STAFF REPORT
COMMUNITY DEVELOPMENT DEPARTMENT

HEARING DATE: 4/1/2021
 TO: Planning & Zoning Commission
 FROM: Joe Dodson, Associate Planner
 208-884-5533
 SUBJECT: H-2020-0122
 3175 N. Ten Mile Rezone
 LOCATION: The site is located at 3175 N. Ten Mile Road, the southwest corner of the Ten Mile and Ustick Road intersection, in the NE ¼ of the NE ¼ of Section 3, Township 3N., Range 1W.

Request to rezone a 1.16 acre property from R-4 to the L-O zoning district commensurate with a provision within the Meridian Comprehensive Plan for the purpose of constructing an approximate 10,000 square foot office building in lieu of residential development, by Mason & Associates.

B. Concept Site Plan

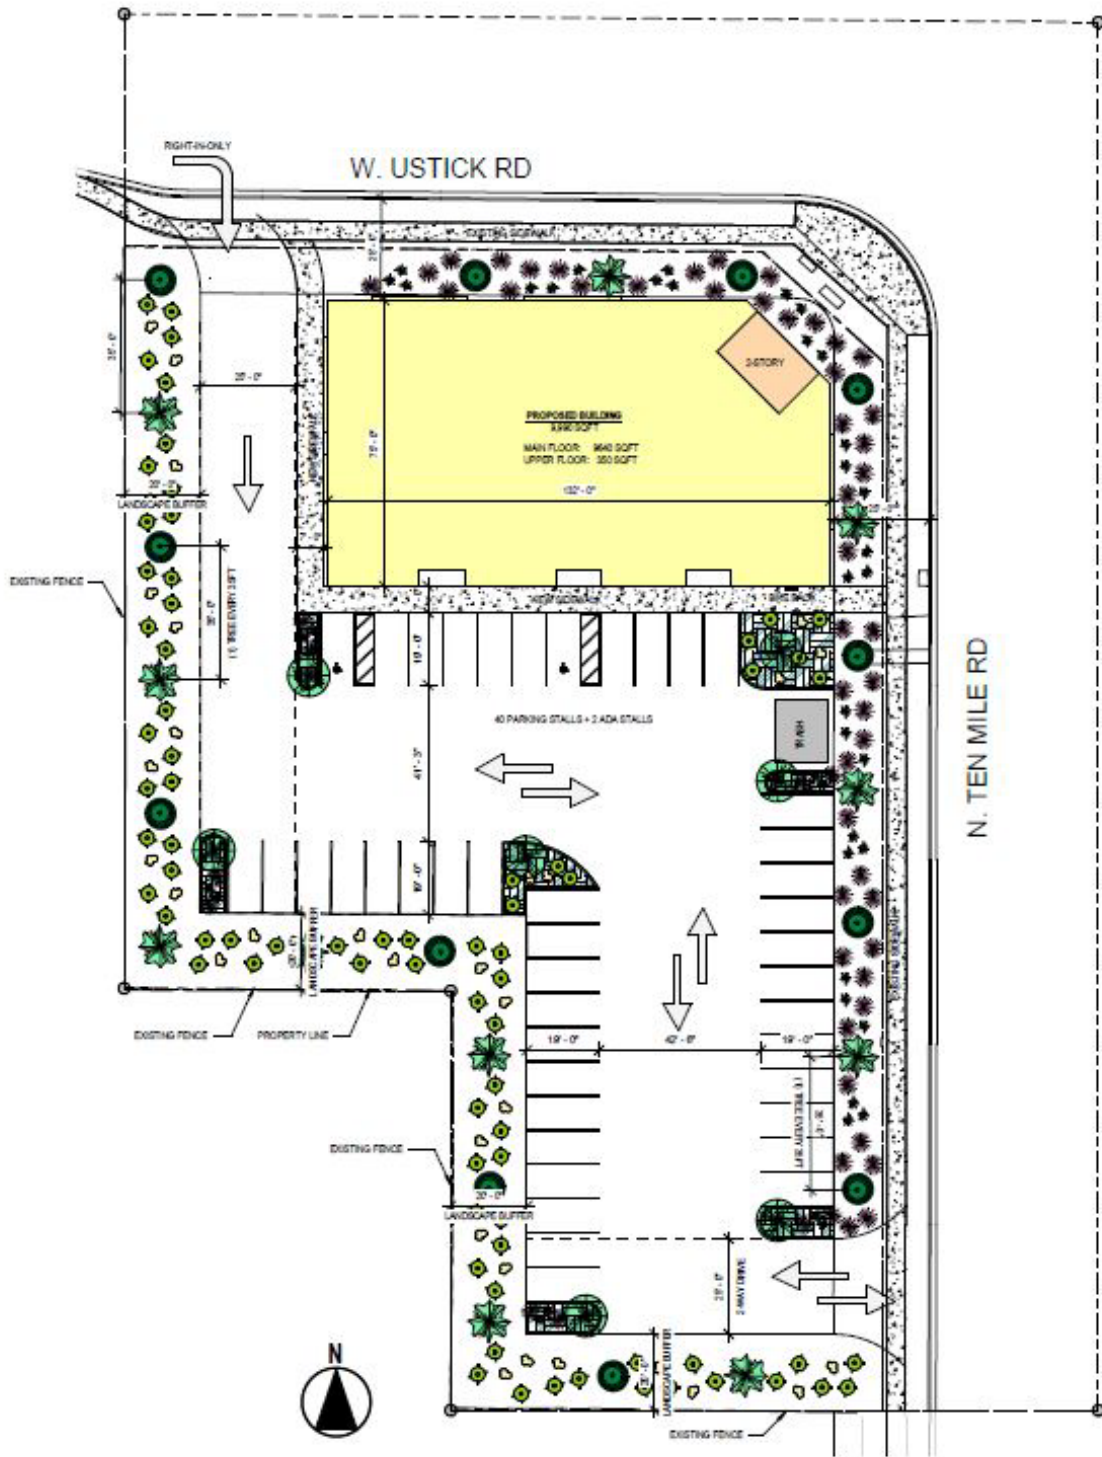
The existing DA provision that requires a 20' landscape buffer adjacent to the three existing residences to the south and west. The submitted site plan shows this buffer with adequate landscaping and therefore compliance with this provision. A number of the parking spaces are facing directly towards one of the homes and there is an existing wood fence located along the shared property lines. Because the proposed use would have more vehicular traffic than residential, Staff finds that the proposed landscaping and existing wood fencing may not be enough screening to mitigate light and noise pollution from the proposed dental office and parking lot. City of Meridian does not allow double fencing so if any solid fencing were to be required it would have to replace the existing fencing and may require this Applicant work with the adjacent homeowner if the fence is not owned by this land owner, convoluting the process and end result. The Applicant should work with the adjacent homeowners to replace the wood fencing with privacy vinyl fencing.

The submitted site plan shows parking space at the required 19' depth and 9' width with all drive aisles being at least 25' wide to accommodate two-way traffic and adequate space for emergency services. In addition, the main drive aisle in the center of the site is at least 41' wide which is well beyond the required width.

As noted above, the Applicant is showing the DA required 20' landscape buffer but Staff believes there is a better use of the site area when the drive aisle width is also considered. For example, to further mitigate any issues with the proposed office use and parking spaces abutting the residential homes, the Applicant could widen the landscape buffer that abuts 3079 N. Firelight Place (the home at the southwest corner of the site). The Applicant could widen this buffer to 30' wide and pull the proposed parking spaces even further from the fence. Increasing the buffer width and therefore requiring additional landscaping is a better alternative to replacing the existing fencing. Staff recommends that a wider landscape buffer be required to help minimize noise and light pollution.

Access to the site is proposed via two connections to the adjacent arterials—one right-in only access is proposed to Ustick and one right-in/right-out access is proposed to Ten Mile. The proposed access to Ustick does not meet ACHD policies but was a negotiated access at the time the property sold. The proposed access to Ten Mile **does** meet ACHD policy and is recommended for approval by ACHD within their staff report. See their report in Section VIII.D for more detailed information on the ACHD site specific conditions of approval.

Staff supports the proposed and limited access to Ten Mile Road commensurate with the approval from ACHD. In addition to the access to Ustick not meeting ACHD policy, the City can restrict access for the development further despite ACHD previously granting the access with the sale of the property. The proposed access to Ustick is proposed as an entrance only into site but there would be no true way to restrict vehicles from utilizing it as an exit as well. In addition, this access point is directly within a right-hand turn lane on Ustick which furthers the safety issues associated with this access point. Therefore, through UDC 11-3A-3, Staff recommends the proposed Ustick access **not** be approved and instead utilize it as an emergency only access barricaded with knockdown bollards, to be approved by Meridian Fire.

- a. Show the access to Ustick as an emergency only access;
 - b. The proposed access to N. Ten Mile Road shall be limited to a right-in/right-out only access;

- d. Show the required landscape buffer adjacent to the existing residential uses to be 30 feet wide instead of 20 feet;
 - e. The allowed uses on the subject site shall be limited to professional services, personal services, and healthcare and social services.

C. Conceptual Building Elevations

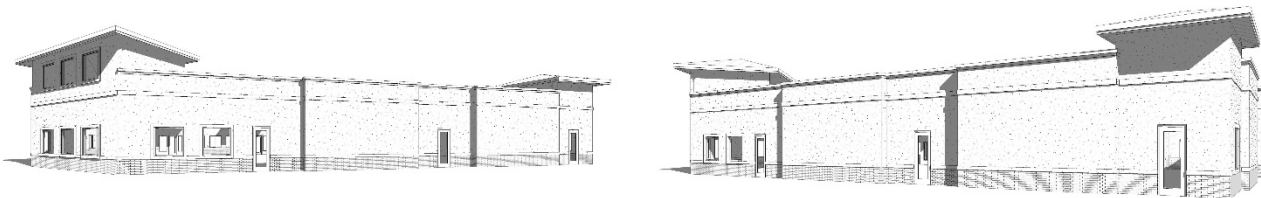
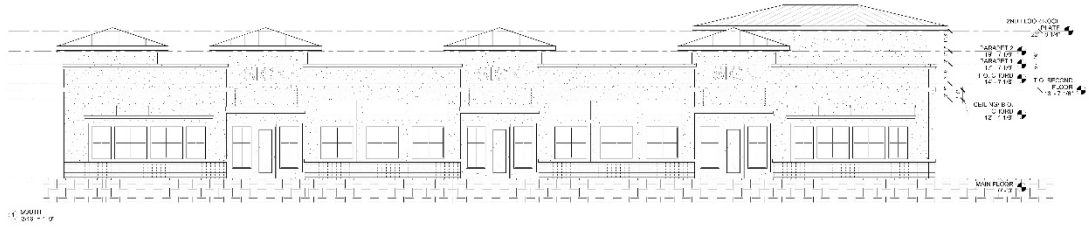
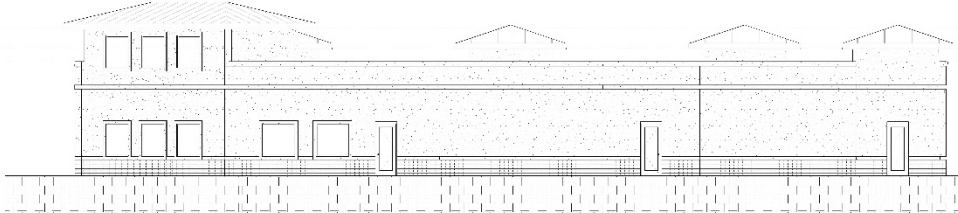
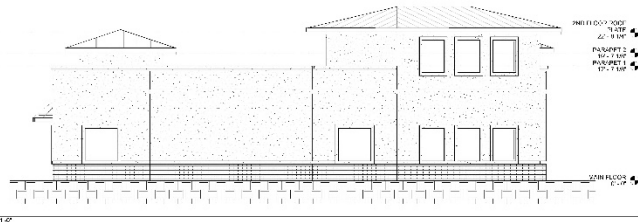
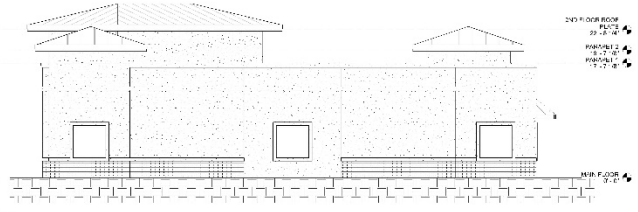
The Applicant submitted conceptual building elevations of the proposed single-story commercial building. The submitted elevations show a single story building approximately 22' to top of plate in the area of the building that directly abuts the intersection; this area is meant to hold the corner of this intersection. The remaining portions of the building are approximately 17.5' in height. Overall the building is shown with varying parapet heights, a stone material banding along the bottom of the building, horizontal wall modulation, and a main field material that appears to be stucco. The south facing elevation also shows awnings and windows nearly the length of the building lending itself to a modern storefront feel.

New commercial buildings require Administrative Design Review prior to building permit submittal so Staff will perform a more complete analysis of the proposed elevations at the time of that application submittal. Staff recommends the north facing elevation incorporate an additional field material to satisfy one or more of the architectural standards.
